Product Change Notification

Product Group: OPT/Tuesday September 1, 2026/PCN-OPT-1495-2026-REV-0

IL41x, BRT2x, VO41xx, VO306x OptoTRIACs green production line transfer

DIP-6

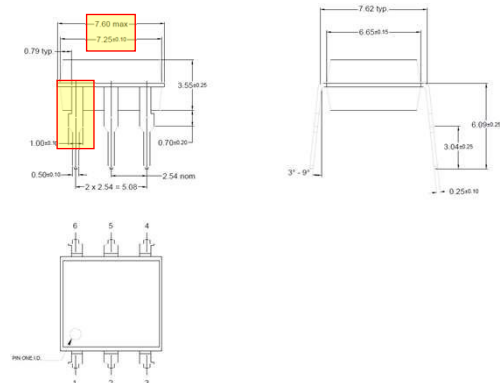
Note: major changes are the package length and the lead shape form

DIP-6, 400 mil (option 6)

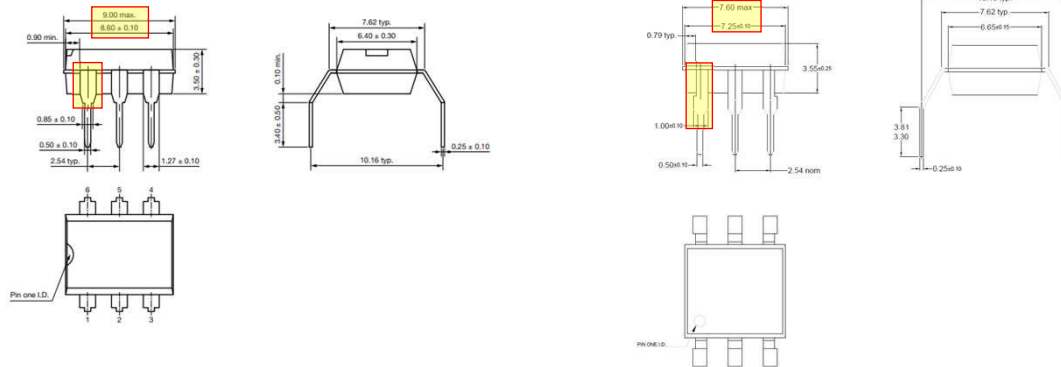
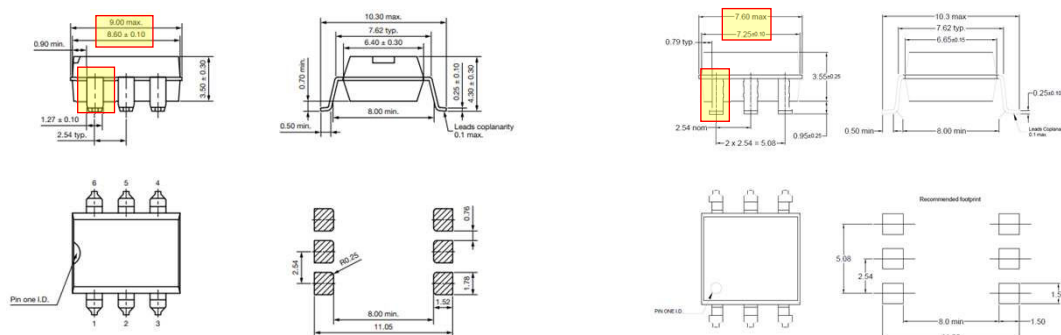
Note: major changes are the package length and the lead shape form

SMD-6 (option 7)

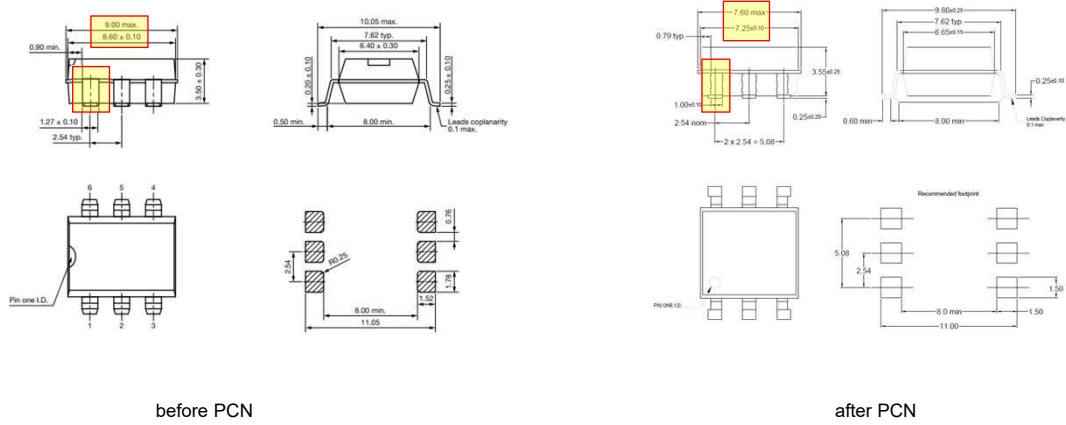
Note: major changes are the package length and the lead shape form
